Access Compliance Report

Public Rights-of-Way

(Curb Ramps)

Intersection ID: 3261	Main Street: BILLINGHAM_DR	Cross Street: MCKENDREE_WY	Location: SE
ADA ID: FA25095E797A	Ramp Type: Perp	Initial Pass/Fail: Fail	Overall Compliance: No
Severity Score: 16.25			
Codes/Mitigation Info/Possible Solution		Field Measurements/Component Compliance

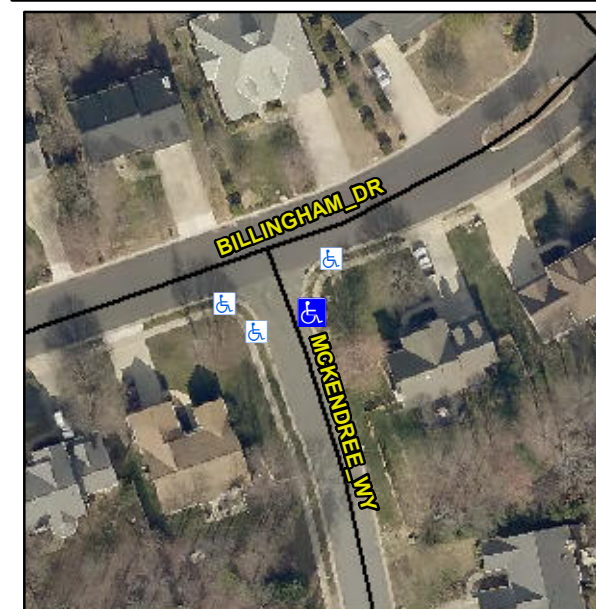
Not Found, R304.5.3, R302.7

Compliance	Description	Data	Compliance	Description	Data
N/A	Ramp Length (in)	47.0	Yes	Ramp Slope (%)	5.0
Yes	Ramp Width (in)	49.0	No	Ramp XSlope (%)	2.2
N/A	Flare Type LT	N/A	N/A	Flare Type RT	N/A
N/A	Flare Slope LT (%)	N/A	N/A	Flare Slope RT (%)	N/A
N/A	Flare Traversable LT?	N/A	N/A	Flare Traversable RT?	N/A
N/A	Landing Length (in)	N/A	N/A	DWS Provided?	N/A
N/A	Landing Width (in)	N/A	N/A	DWS Contrast?	N/A
N/A	Landing Slope (%)	N/A	N/A	DWS Length (in)	N/A
N/A	Landing X Slope (%)	N/A	N/A	DWS Full Width?	N/A
N/A	Landing Curb? (Y/N)	N/A	N/A	DWS Offset (in)	N/A
N/A	Shared Landing?	N/A			
N/A	Gutter Ponding?	N/A	N/A	Gutter Slope (%)	N/A
N/A	Gutter Lip Ht (in)	N/A	N/A	Gutter X Slope (%)	N/A
N/A	Painted X Walk1?	No	N/A	Painted X Walk2?	N/A
	X Walk 1 Direction	To W		X Walk 2 Direction	N/A
N/A	X Walk 1 Width (in)	N/A	N/A	X Walk 2 Width (in)	N/A
	X Walk 1 Slope (%)	5.4		X Walk 2 Slope (%)	N/A
	X Walk 1 X Slope (%)	1.1		X Walk 2 X Slope (%)	N/A

N/A	Ramp inside XWalk1?	N/A	N/A	Ramp inside XWalk2?	N/A
	Road Slope (%)	N/A	N/A	Clear Space?	N/A
	Road X Slope (%)	N/A	N/A	Clear Space to XWalk (in)	N/A
N/A	Any Obstructions?	N/A	N/A	Storm Grate/Utility Hazard?	N/A
	Obstruction Type			Storm Grate/Utility Type	
		N/A			N/A
		No		Surface Condition? (G/P)	Poor

Remove & Replace Entire Ramp.
